TECHNICAL BULLETIN

[Issue No.] T99-0061

[Title] Additional orientation for mounting CC-Link compact remote I/O modules to DIN rail

[Relevant Models] AJ65VBTCE3-32D, AJ65VBTCE32-32DT

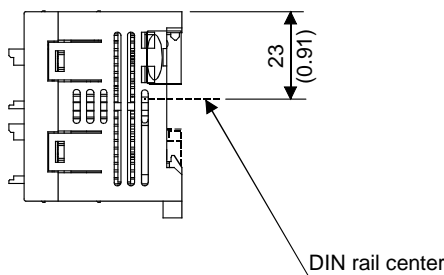
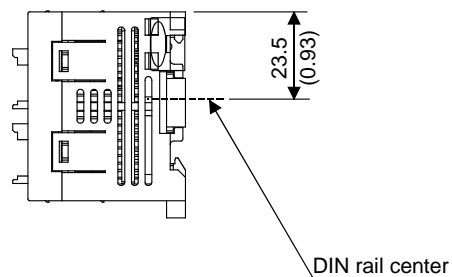
(1) The length from the module's end face to the center of the horizontal DIN rail has been changed.

Some of the external dimensions have been changed due to addition of the vertical mounting orientation. Please pay attention to these changes when fixing modules to a control panel.

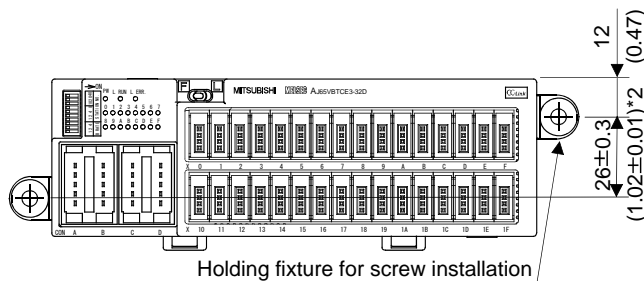
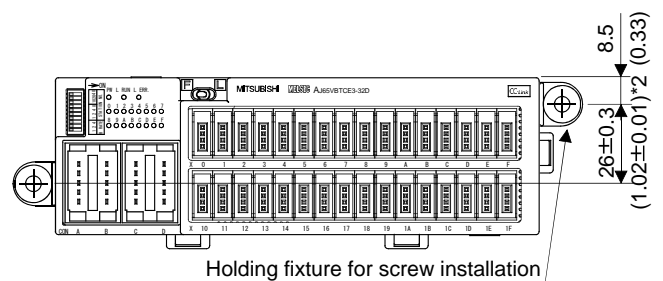
(2) The length from the module's end face to the center of the holding fixture for screw installation has been changed.

*2: The length needed for screw installation (mounting pitch) has not been changed.

4. External dimensions

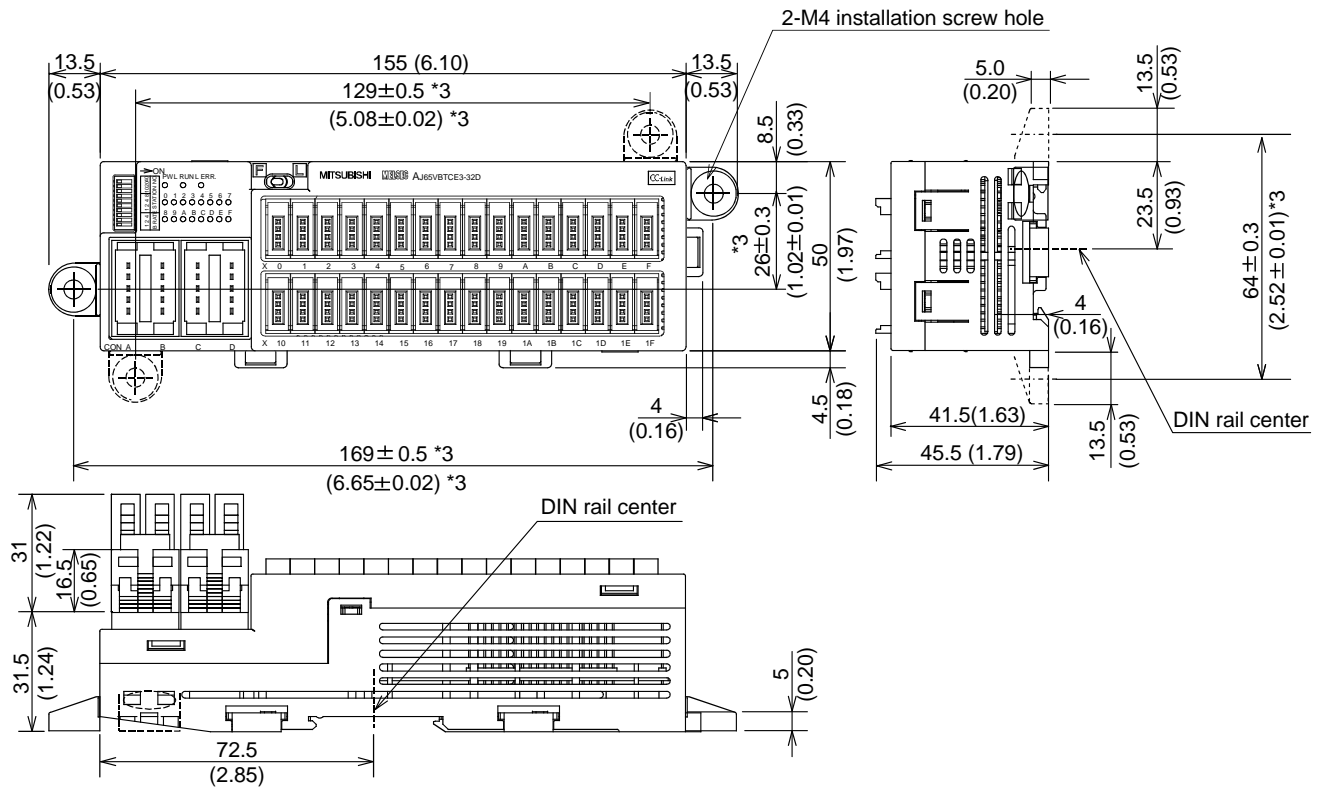
The following shows the external dimensions of the module that can be vertically mounted to the DIN rail.

*3: Adjust the screws to ensure this length. (Mounting pitch)
